Product Similarity Declaration

Product name: Magnet Wireless Charger

Model name: IPR26, CPR26, KPR26, IPW26

FCC ID: 2AP2N-IPR26

Differential photos	V1.10 旧版本	V1.20 新版本

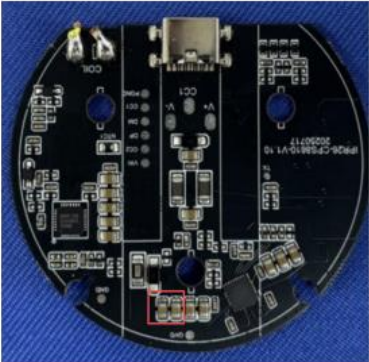
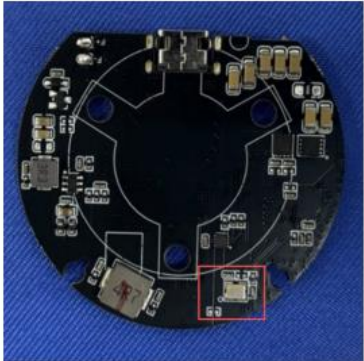
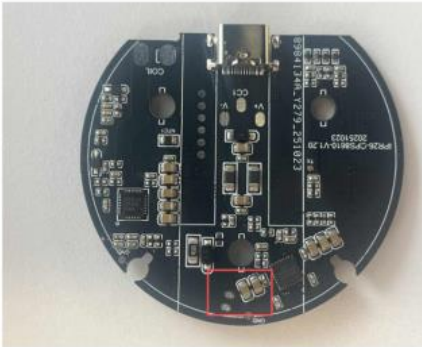
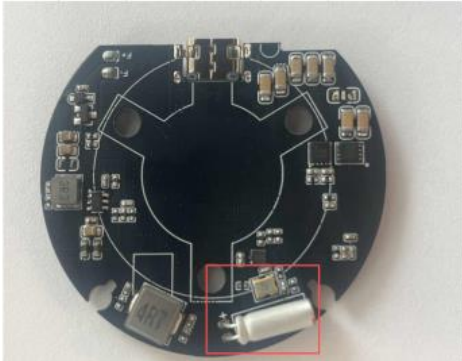
V1.10 旧版本  	V1.20 新版本  
Differences description	The motherboard was modified because of the noise issue caused by wireless charging. Two surface-mount capacitors were replaced with one electrolytic capacitor of a slightly larger size, All models have two hardware versions.	
accessories
